46T-17
Dealer 12
October 9, 1946

Subject: BUMPER JACK CAMPAIGN

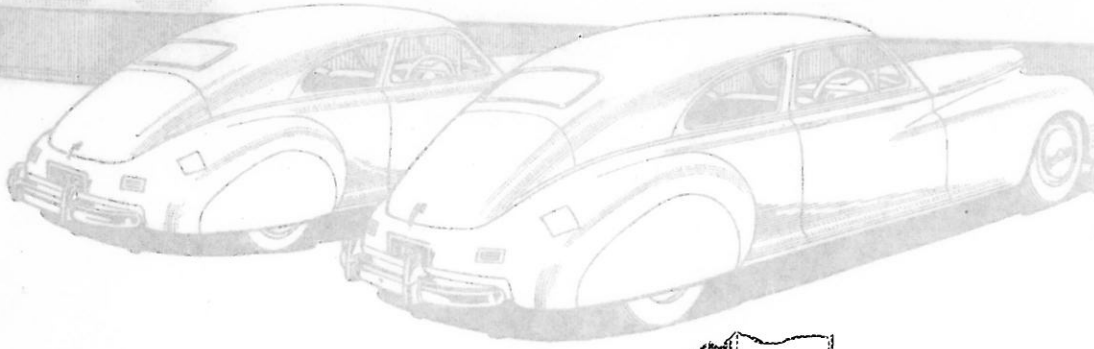
The manufacturer of the bumper jacks furnished in the tool kits of all new 21st Series cars has made a change in the method of welding the lifting saddle to the elevator assembly.

Prior to this change the lifting saddle was secured by three spot welds on each side. The manufacturer has now added a weld along both the upper and lower edges of the saddle as shown on the reverse side of this bulletin.

Dealers should immediately call in and reweld the jacks supplied with all cars in their sales area shipped from the Factory prior to August 21, 1946.

Welding can be done by either acetylene torch or electric arc without disassembling the jack. After the weld has cooled, the saddle and elevator assembly should be painted to restore its original appearance and to prevent rusting.

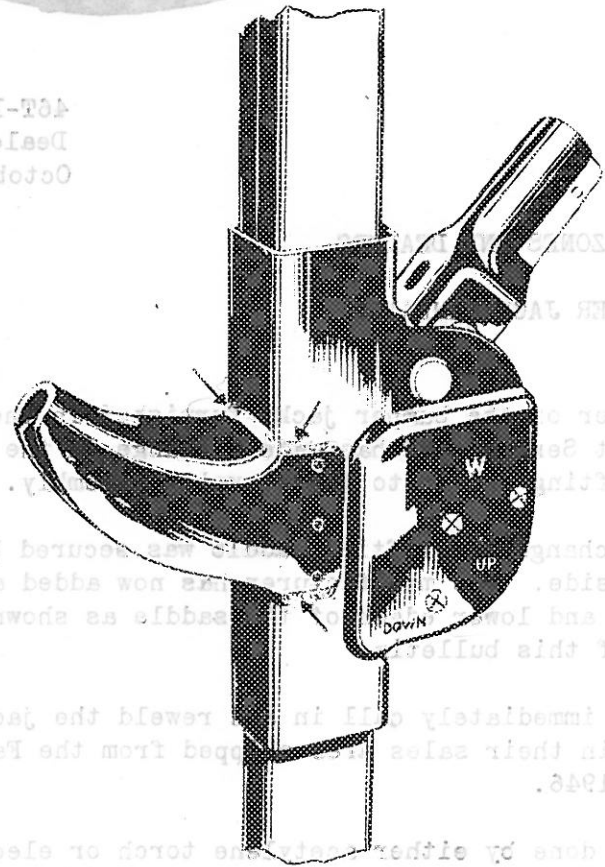
The manufacturer of all new 1946 Packard Sedans and Packard Sedan Coupes is now adding a method of welding the bumper jack to the bumper assembly. Prior to this change, the bumper jack was secured by three spot welds on each side. The new method now adds a weld along both the upper and lower edges of the bumper saddle as shown on the reverse side of this bulletin.

Welding can be done by either using an oxy-acetylene torch or electric arc without disassembling the jack. After the weld has cooled, the bumper and elevator assembly should be painted to restore its original appearance and to prevent rusting.
